AMENDMENT TO ALLOW CONSTRUCTION OF 60 SPACE PARKING LOT SOUTH OF CHURCH AND ASSOCIATED ACCESS TO LA ORILLA ROAD

TAYLOR RANCH BAPTIST CHURCH
 La Orilla & Golf Course Road N.W.
 Albuquerque, New Mexico

SITE PLAN / UTILITIES, CURB & GUTTER, DETAILS, PARKING LAYOUT

DRB 95-194

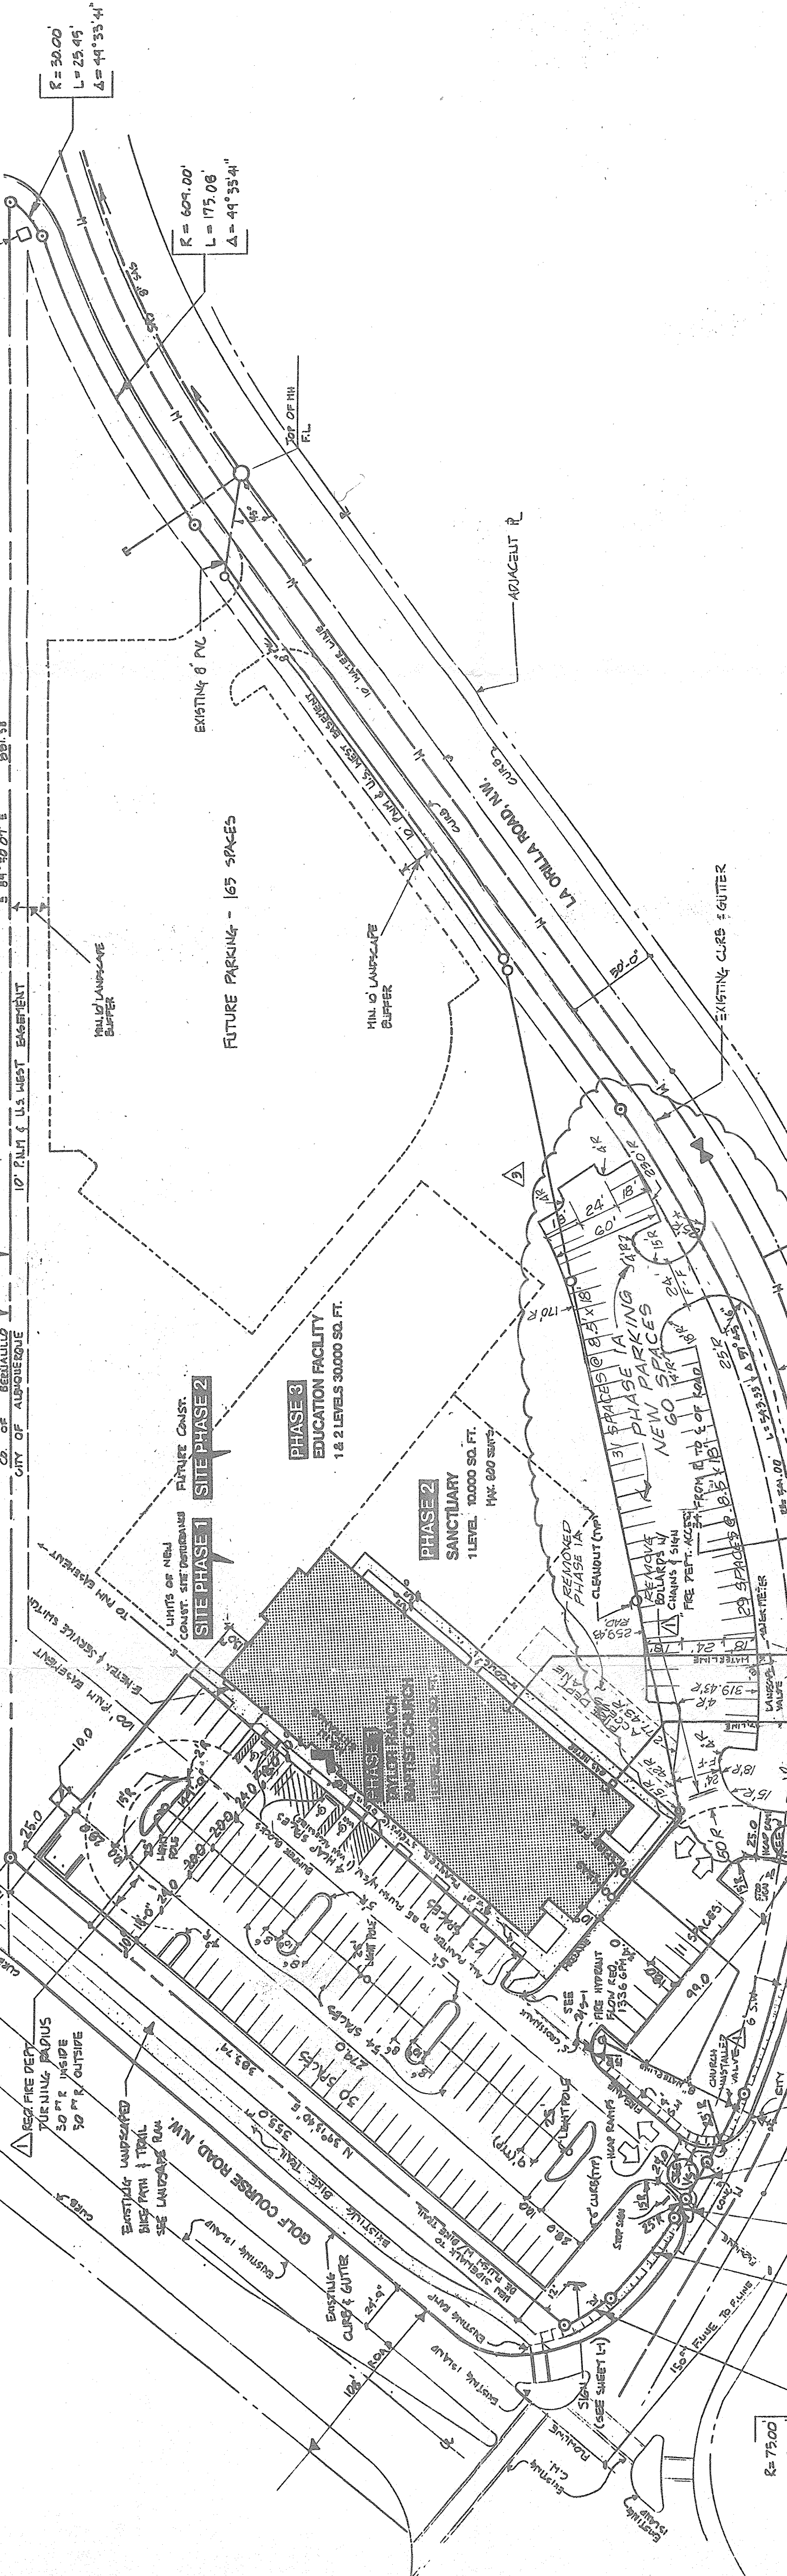
- CONSTRUCT 60-SPACE PARKING LOT SOUTH OF CHURCH, INCLUDING NEW ACCESS TO LA ORILLA ROAD.
- REMOVE BOLLARD WITH CHAIN CONFIGURATION AND FIRE DEPT. ACCESS LANE (CHANGE Δ).
